**MEMORANDUM**

**REVIEW TYPE:** Final Water Quality Plan and Site Plan Review  
**APPLYING FOR:** 203,262 s.f. of Hospital  
**PROJECT NAME:** Shady Grove Seventh Day Adventist Hospital  
**CASE #:** 8-99024A  
**REVIEW BASIS:** Sec. 59-D-3, M. C. Zoning Ordinance  
 Section 19-64 Final Water Quality Plan  
**ZONE:** LSC  
**LOCATION:** Medical Center Drive, North of the intersection of Medical Center Drive  
 and Medical Center Way  
**MASTER PLAN:** Shady Grove Study Area Approved, July 1990  
**APPLICANT:** Shady Grove Seventh Day Adventist Hospital  
**FILING DATE:** October 20, 2002  
**HEARING DATE:** May 6, 2004

## **STAFF RECOMMENDATION Site Plan Review #8- 99024A:**

OVERALL LANDSCAPE PLAN

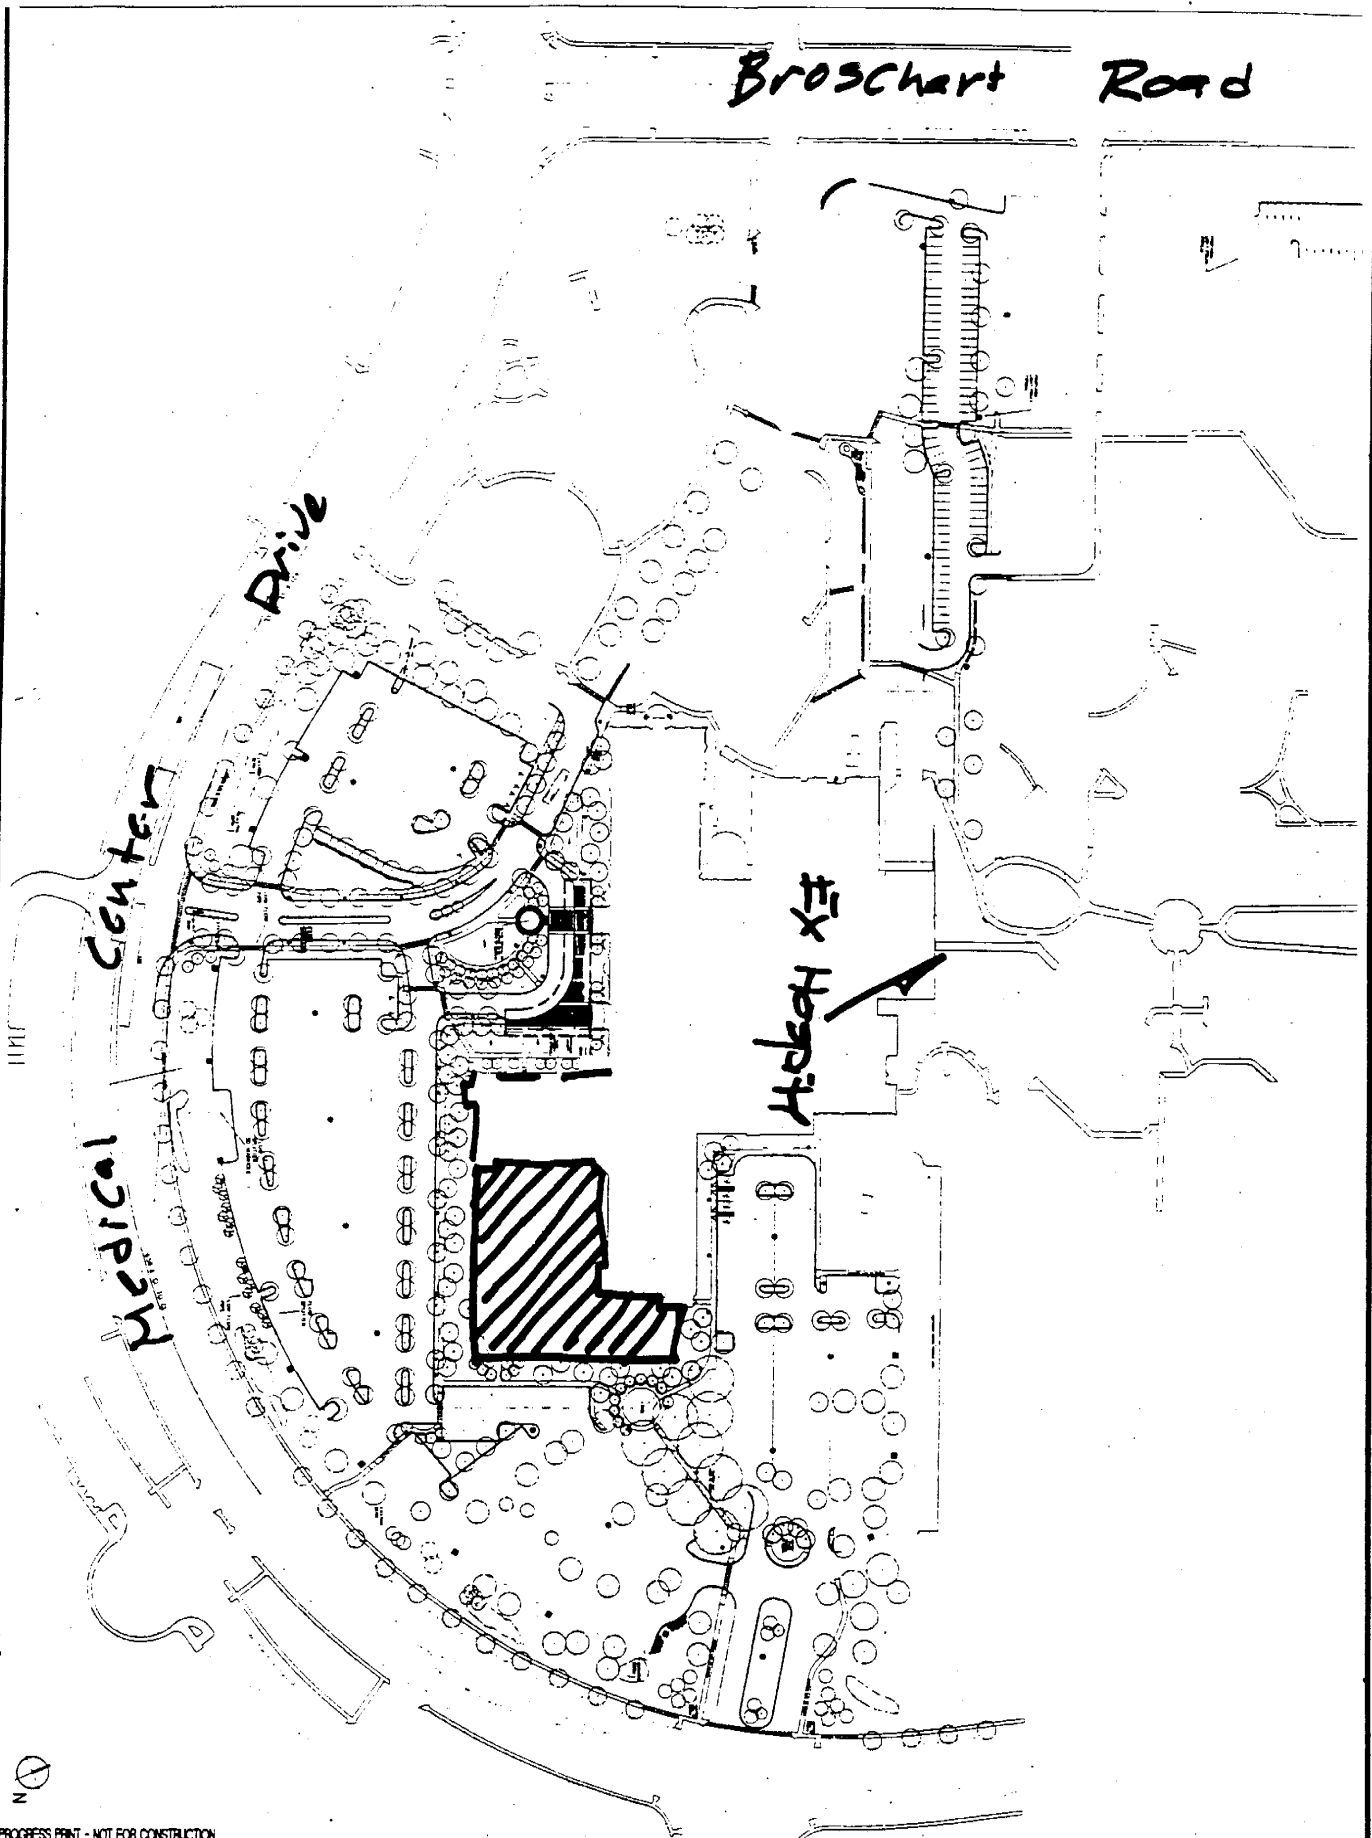
Landscaping includes shade trees within the parking lot, shrubs within and around the edges of the parking lot to screen the vehicles. The front entry has been embellished with extensive landscaping within the boulevard entrance. The front entry now includes generous sitting areas with multiple benches and gardens that allow for waiting room overflow.

Lighting has been provided for the parking lots with light fixtures that resemble the fixtures recommended in the SGLSC Development Plan. The light levels approach 4 foot-candle average with 1000 watt lamps; IESNA guidelines recommend 1.5 – 2.5 foot-candles for parking lots. A subsequent lighting plan will be submitted.

3. A lighting plan shall be submitted for staff review that shall include light levels that cut off at the property line and have even light levels throughout the site at IENSA approved levels.
